Site Instruction

Project Name: AQUAVISTA - Bayside

SI No.: E 038

Title: EV Charging Stations.

E0-01

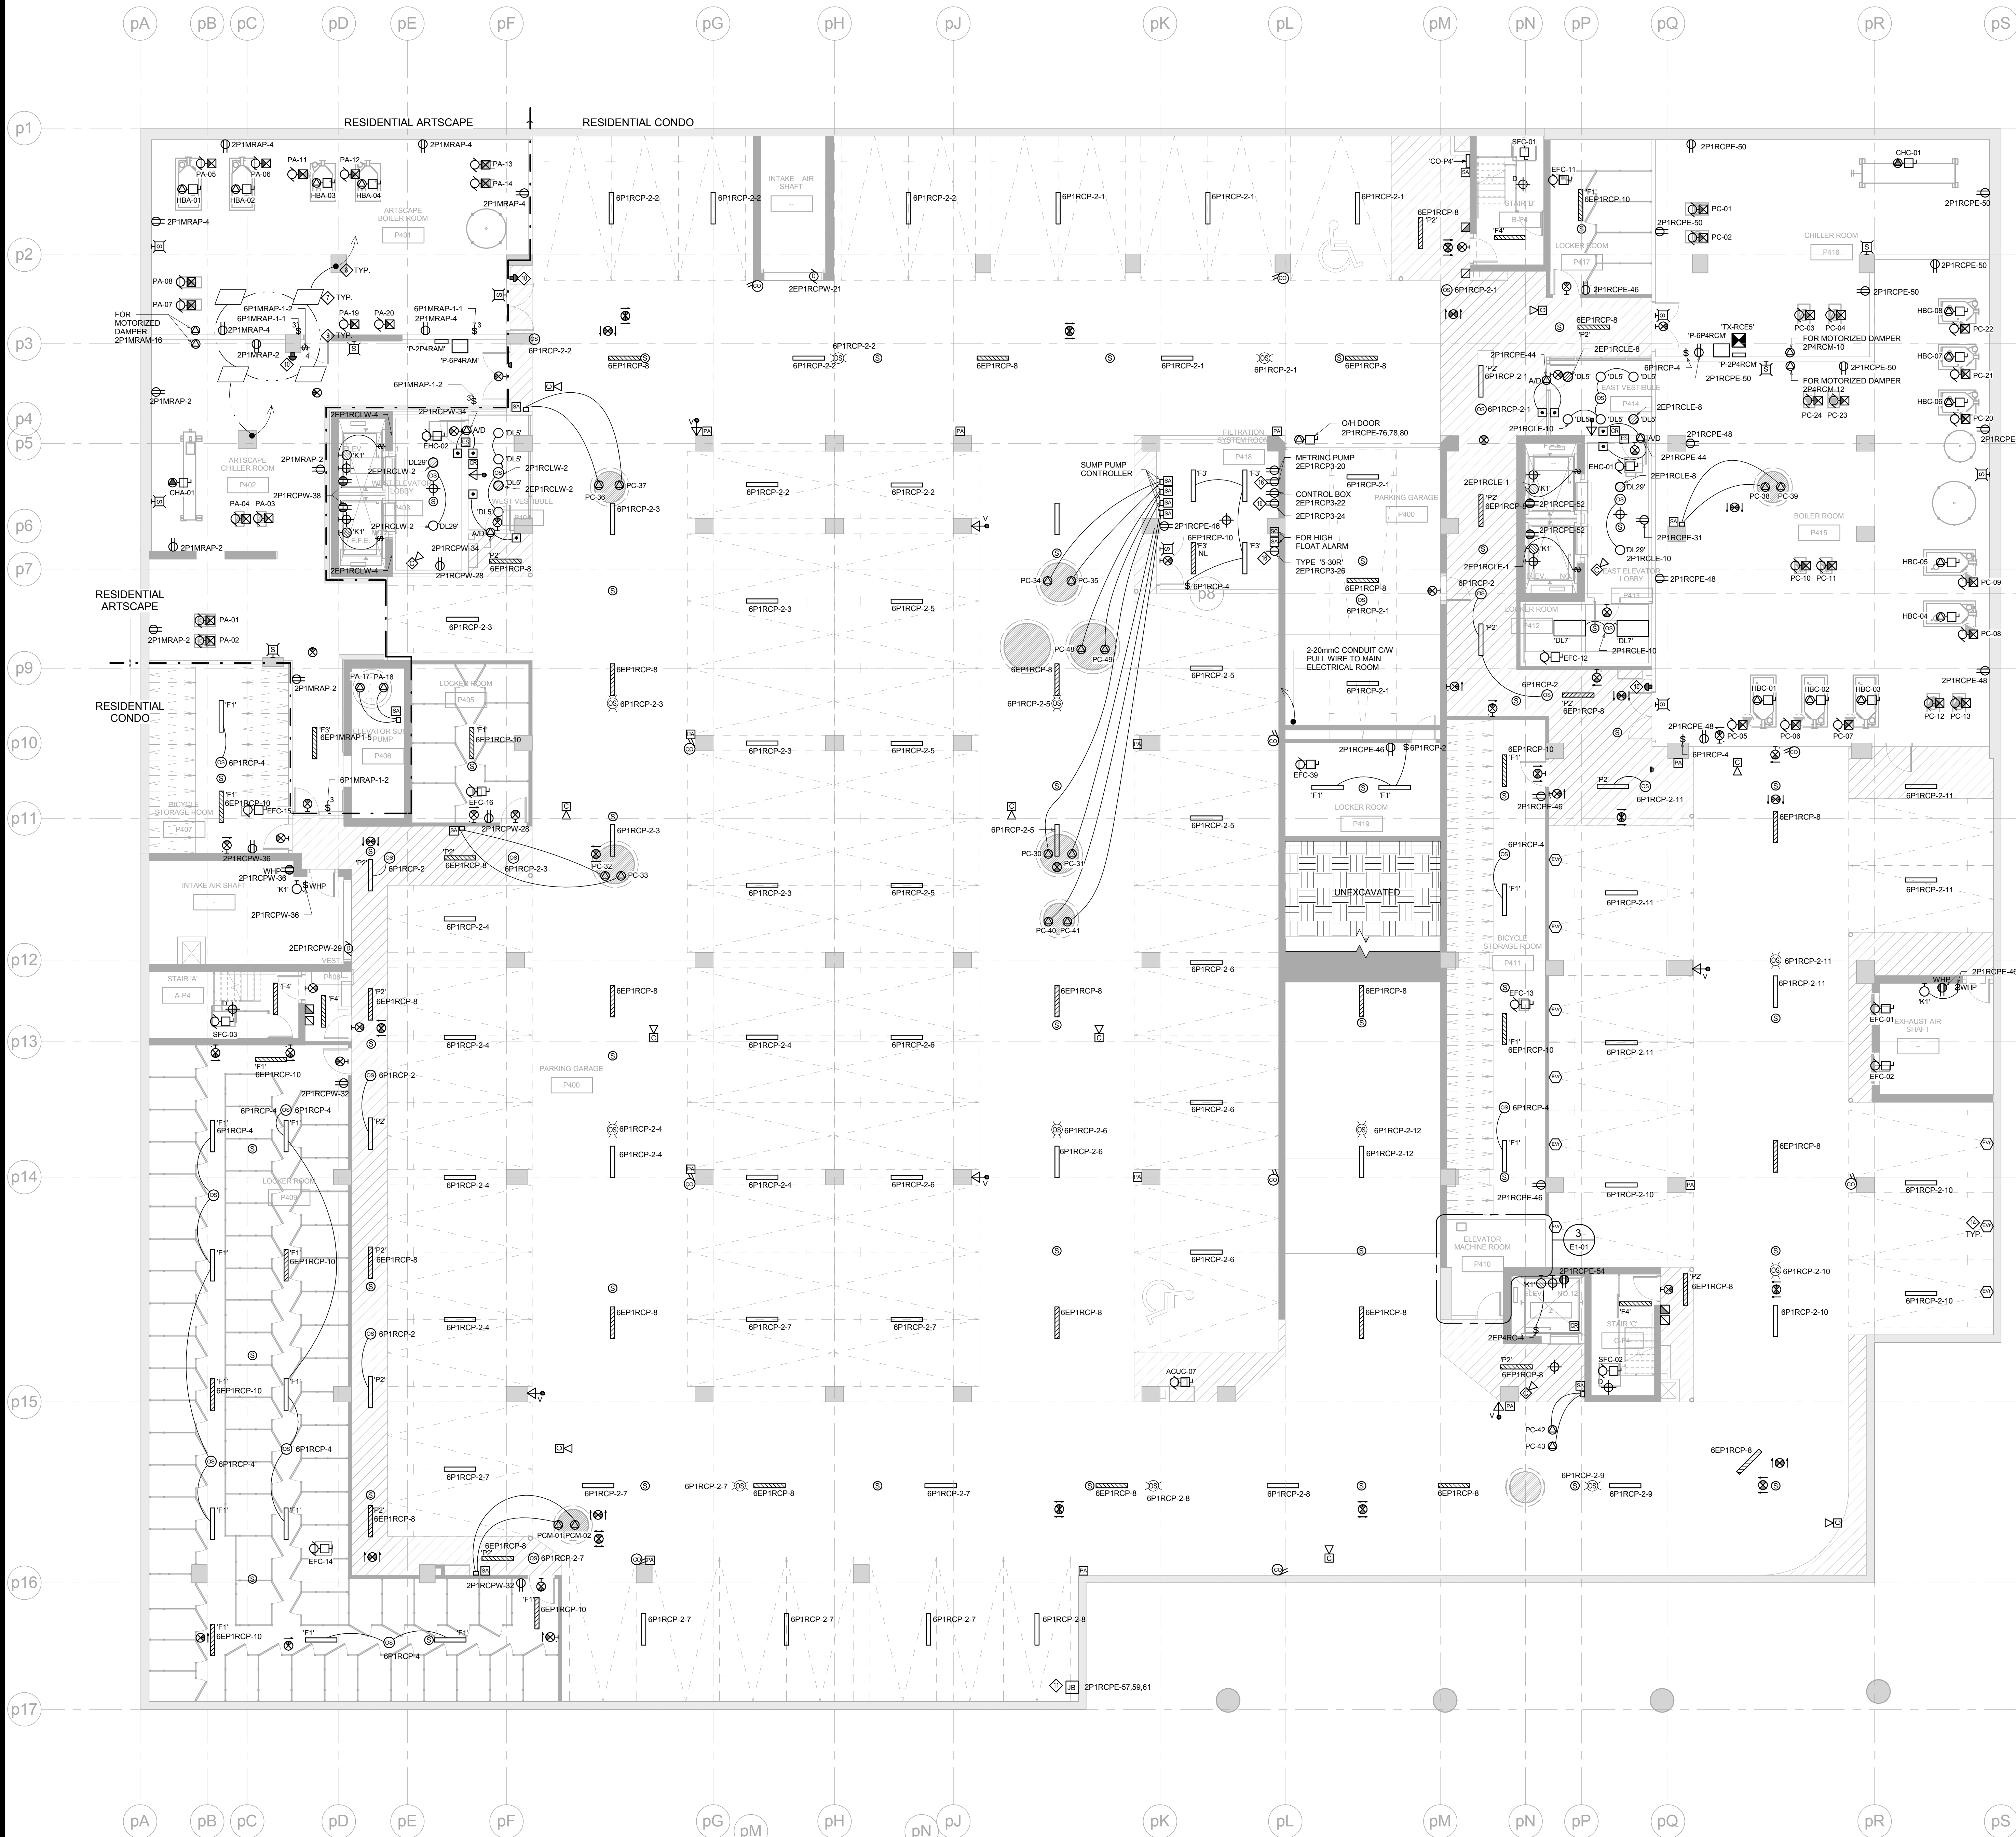
Drawing No.	Drawing Issued	Items
Electrical drawings have been revised to address the EV charging replacement from Type-1 to Type-2		
E0-01	Yes	EV charging legend has been updated.
E1-01, E1-02	Yes	- Replace type-1 charging stations with type-2 (Total Qty-7). - Feeders and conduits to be upgraded for this change. - Coordinate with metering contractor for required metering modifications and CT replacements.
